HISTORIC PRESERVATION BOARD STAFF REPORT

Sundy Village – Building A (The Rectory)

Meeting	File No.	Application Type
May 5, 2026	HP-446-2026	Level 1 Site Plan Modification and Certificate of Appropriateness

Proposed detail of hood vents on the roof of Building A (The Rectory)

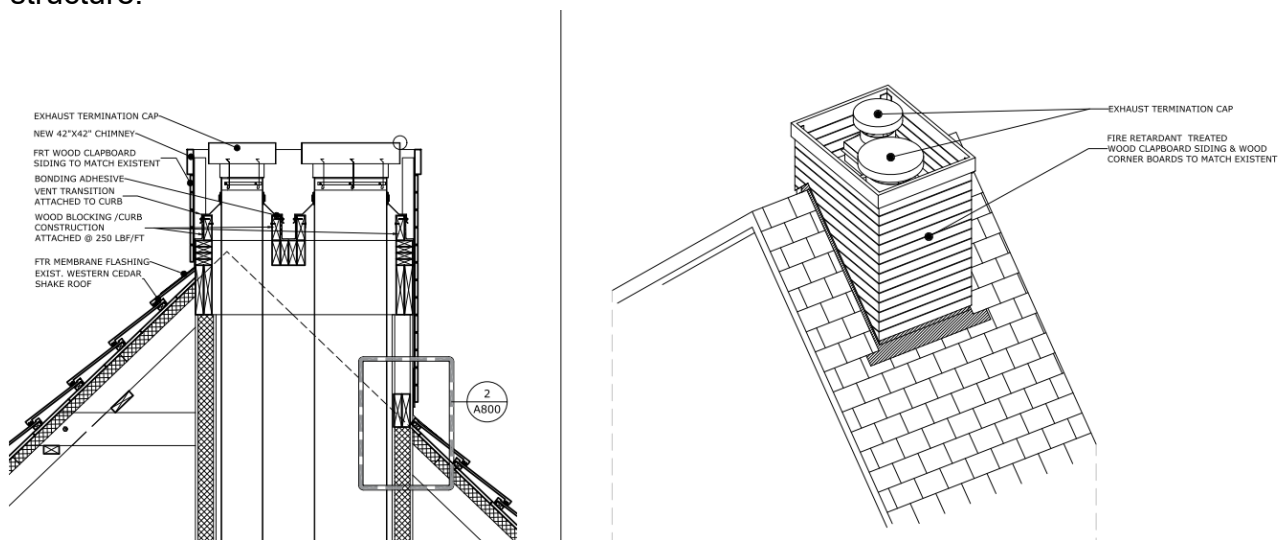
Standards 1, 2, 3, 5, 9 and 10 are applicable to this request. The subject proposal consists of exterior modifications to an existing historic structure known as Building A (The Rectory), located within the Block 61 portion of the Sundy Village site. With regards to Standards 1 and 2, the structure has been preserved on site and is approved for adaptive reuse as a restaurant. With respect to Standards 3, 5, 9 and 10, all exterior modifications to the structures are minor as they include the construction of two new hood vents to the roof and a new design for the screening around the approved mechanical equipment located on the rear (west) roof terrace for restaurant use. The hood vents will be screened with a wood chimney design and will be located on the northwest and southwest ends of the roof (see below). Use of false chimneys is the simplest approach to screening the roof mounted hood vents but could be seen as adding conjectural elements to the structure (Standard 3). The mechanical equipment on the roof terrace is proposed to be screened with a new wood enclosure, designed to match the existing wood siding of the structure which is expected to be compatible with the architectural detailing of the structure.

Proposed detail of mechanical screening on the roof of Building A (The Rectory)

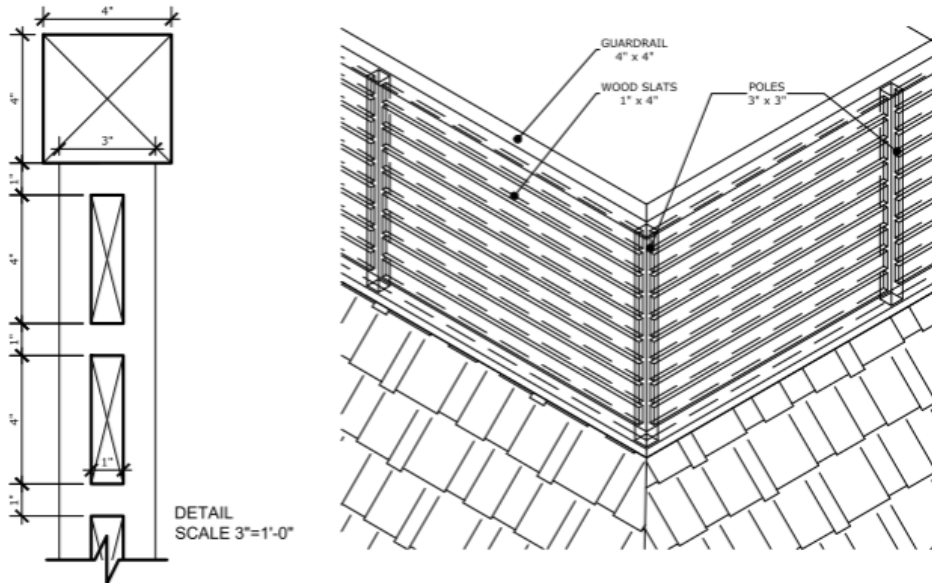
The proposed screening for the approved mechanical equipment located on the roof terrace located on the rear (west) side of the structure will also match the existing wood siding in material size and color where a fence railing was approved.

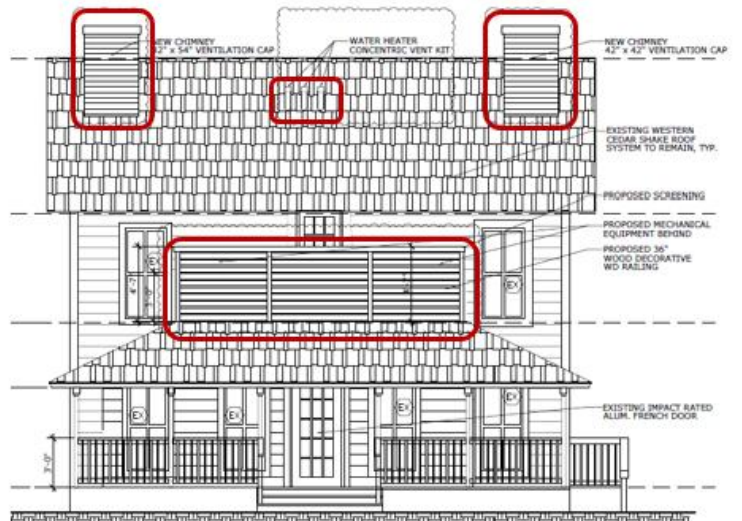
Regarding the exterior changes to the existing windows on the northwest side of the first floor of the structure, the proposal has been designed with decorative blinds inside of the window and a wall to be constructed on the interior side of windows to allow for more kitchen area of the restaurant. The blinds will be visible from the exterior of the structure to provide the windows an appropriate residential appearance. The glass will remain clear to match the existing windows and the windows will be operable on the exterior, to allow for future maintenance or cleaning functions.

It is noted that the modifications to the windows will completely conceal them on the interior, which is not considered an ideal modification to the historic structure. However, there is no concern with regards to any permanent damage to the structure as the interior sheathing can be removed in the future and would not diminish the historic integrity of the structure. The board will need to determine whether the modification is appropriate to the historic structure.

Proposed rendering of mechanical screening & new hood vents on the rear (west) Elevation of Building A (The Rectory)

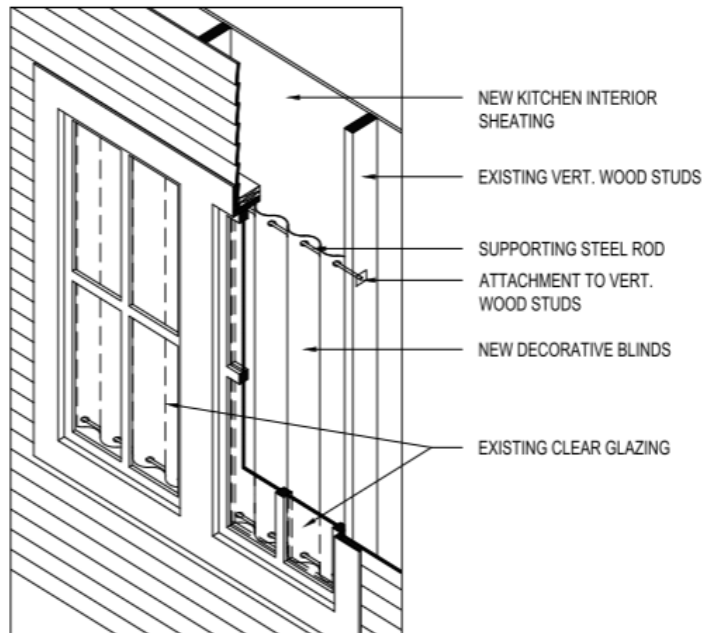
As for **Roof Shapes**, there are no proposed changes to the roof shapes for the subject structure, however it is noted that two hood vents will be placed on the roof to the rear (west) sides of the building, where they will be the least visible from the public right-of-way and so as to not interfere with the historic integrity of the front façade. Their designs will appear to look like chimneys. Given the constraints of converting a structure that was originally designed for residential use to a restaurant, the proposal represents the least impactful architectural approach. There are no concerns with the proposed roof modifications.

With respect to **Relationship of Materials and Color** the proposal includes two new hood vents on the roof to be designed within false chimneys that will be clad with wood clapboard and siding to match the existing structure. It is noted that the original hood vent approval had Hardiboard material for the proposed hood vent screening for Building A (The Rectory), which is no longer being used for the structure.
